Service Bulletin

Bulletin No.: 19-NA-088

Subject: Performance Cold Air Intake Interference at Air Extractor and Hood Blanket

Brand:	Model:	Model Year:		VIN:		Engine:	Transmission:
		from	to	from	to		
Chevrolet	Corvette	2014	2019

5318292

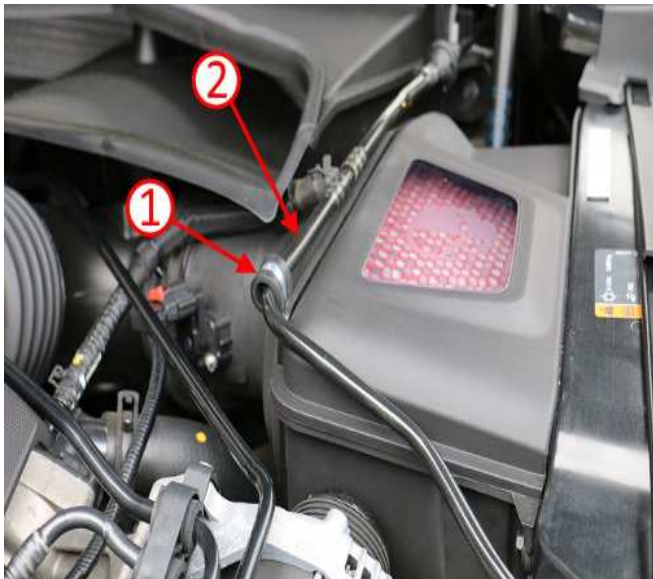
1. Remove and discard the retaining clip (1) that secures the coolant surge hose (2) to the air box.
2. Ensure the coolant hose is retained at original fender clip location (1).
⇒ if this clip is not present, it must be ordered and installed.
3. Rotate the coolant hose clamp (2) approximately 90° forward and check clearance to the hood air extractor and MAF tube. Adjust as necessary.
